TITLE 21 REWRITE

**Assembly Title 21 Committee
September 20, 2012**

**Review of Planning and Zoning Commission Recommended
Amendments to the Provisionally Adopted Title 21**

Date: September 20, 2012
To: Assembly Title 21 Committee
From:  Jerry T. Weaver, Jr., Director
Subject: Review of Proposed Amendments to Provisionally Adopted Chapter 7 – Part I

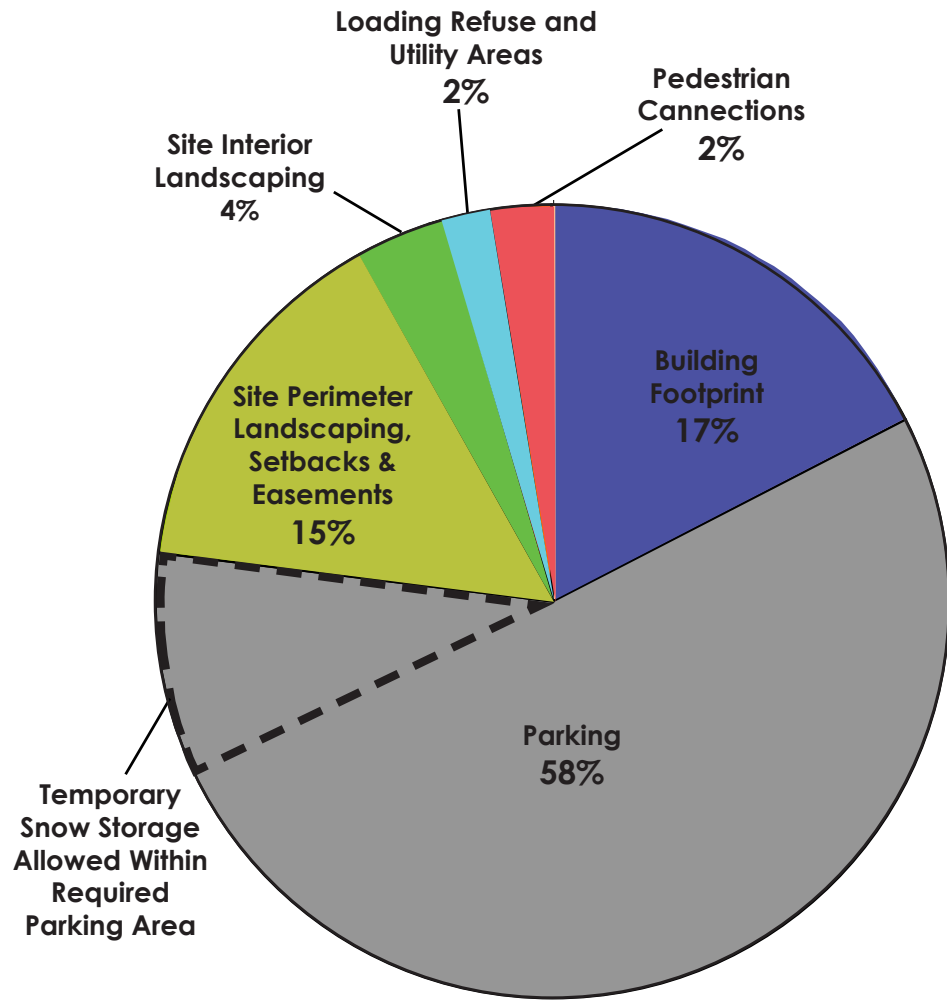
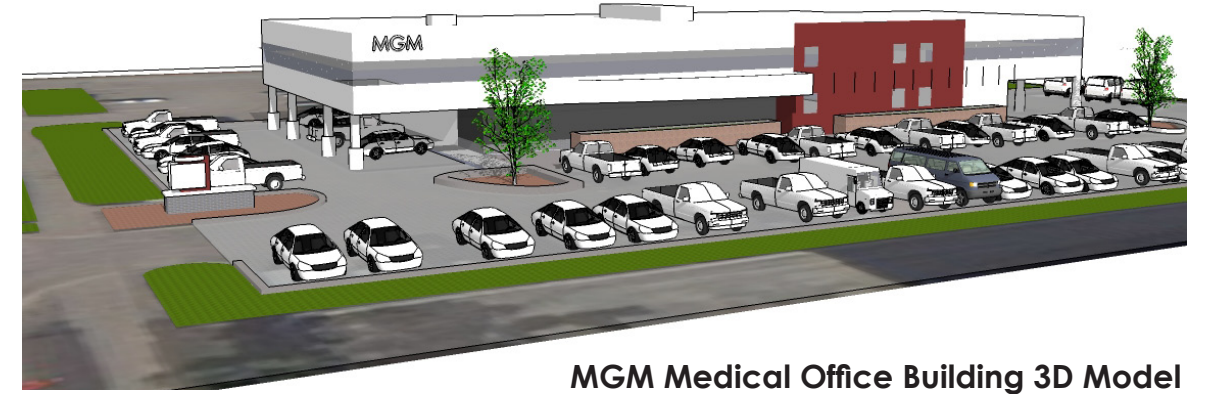
1. Retain section 21.07.060E.4.b., rather than deleting it, and identify specific problems for resolution. For example, if the provision on lines 29-31 prescribing the shortest practical route is too restrictive, it can be adjusted for more flexibility.
2. Amend the last sentence proposed by PZC in section 21.07.060E.4.a., to clarify and qualify it, as follows:

Walkways shall be credited toward a required private open space where they are contiguous. A walkway that crosses a required landscaping bed shall be credited against the required landscaping area and amount of planting material.

Land Area Requirements as a Percent of Total Site - MGM Medical Office Building

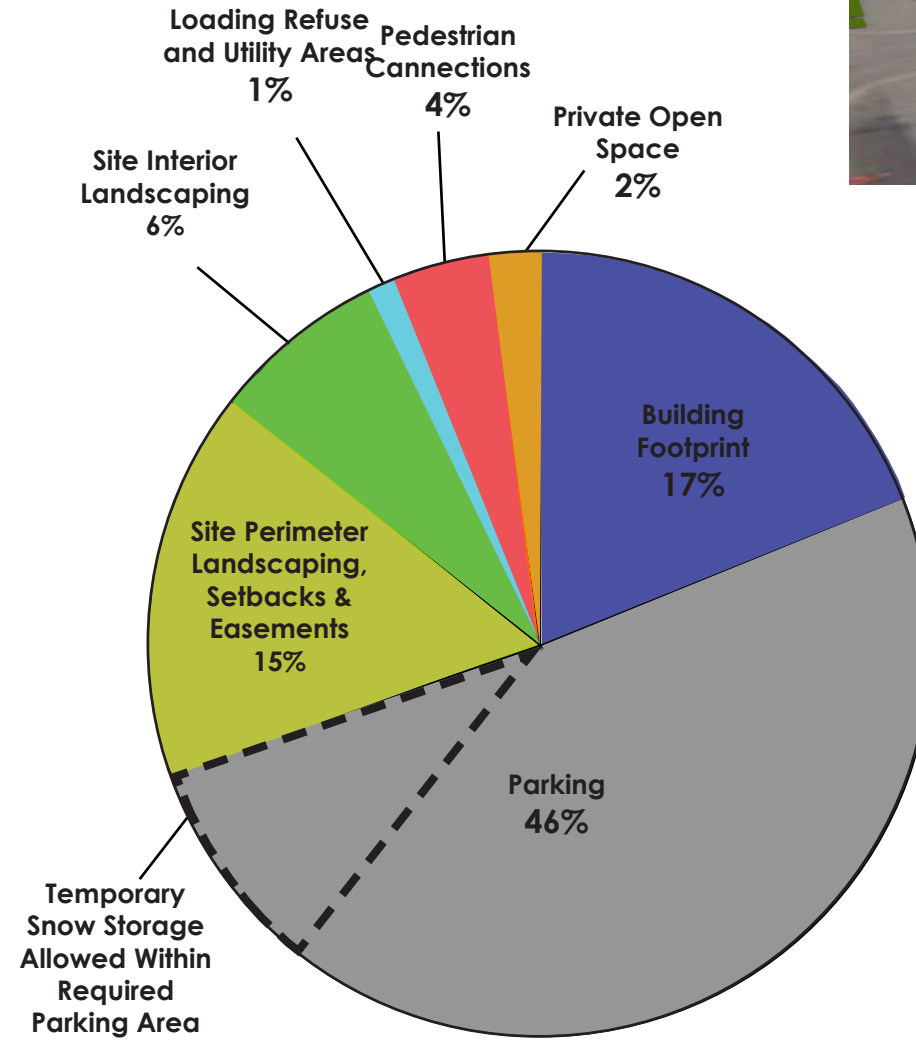
Required perimeter landscaping area is similar for this development under either current and provisionally adopted Title 21, except that under the provisionally adopted Title 21, the minimum bed width along the Lake Otis frontage would increase from 6' to 8' to provide enough space for trees.
